Deck - Left side of house
(replaces existing deck over shed)

Paul J. Jones
126 Sherwood

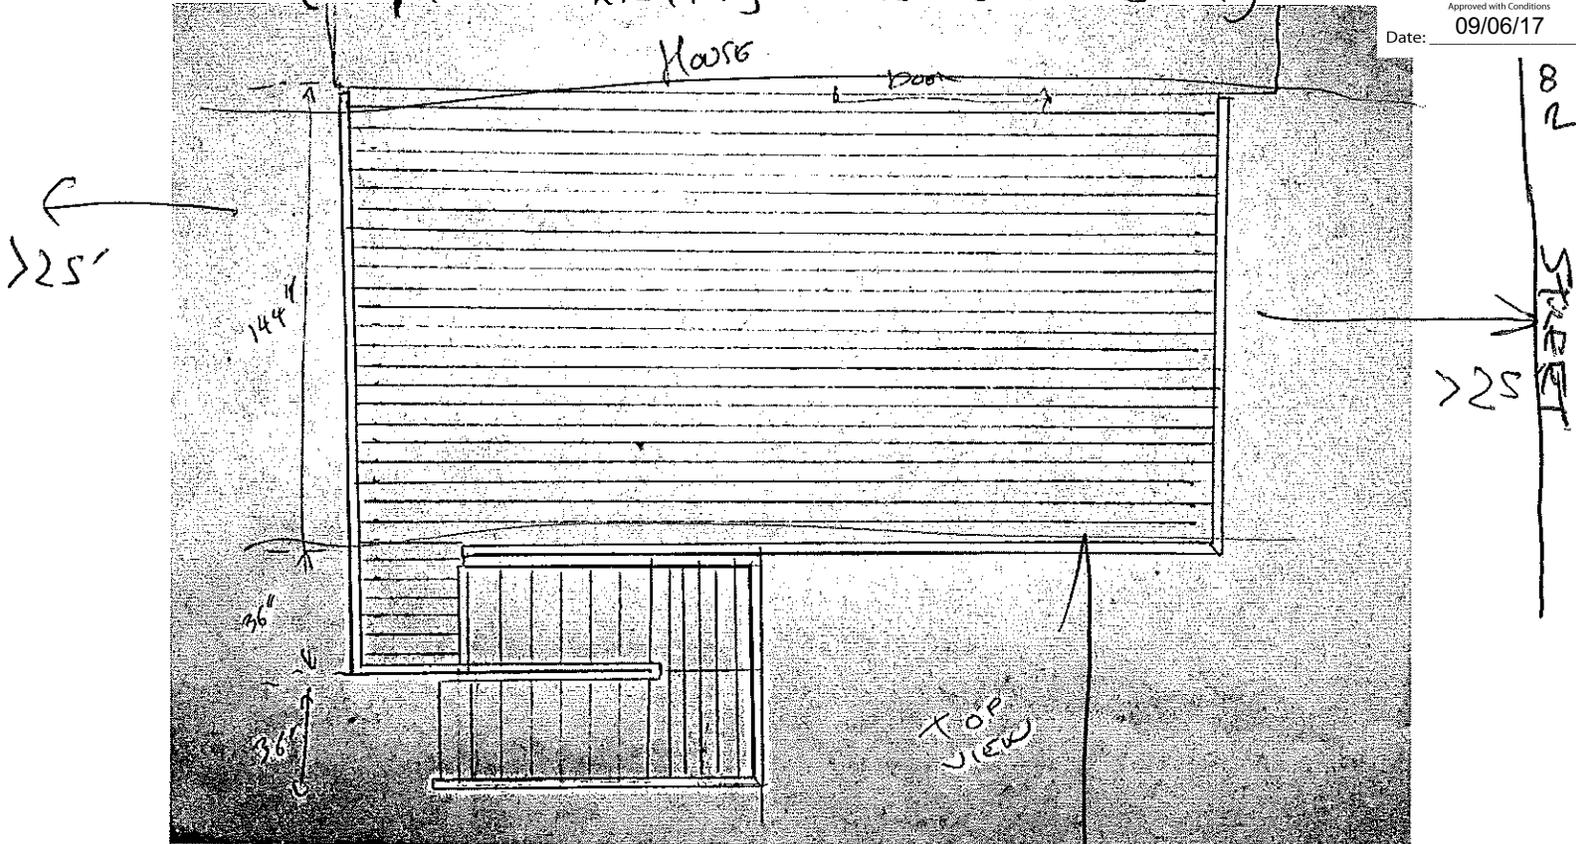
Reviewed for Code Compliance
Inspections Division
Approved with Conditions
Date: 09/06/17

>25' feet
on all 3 sides of
deck perimeter
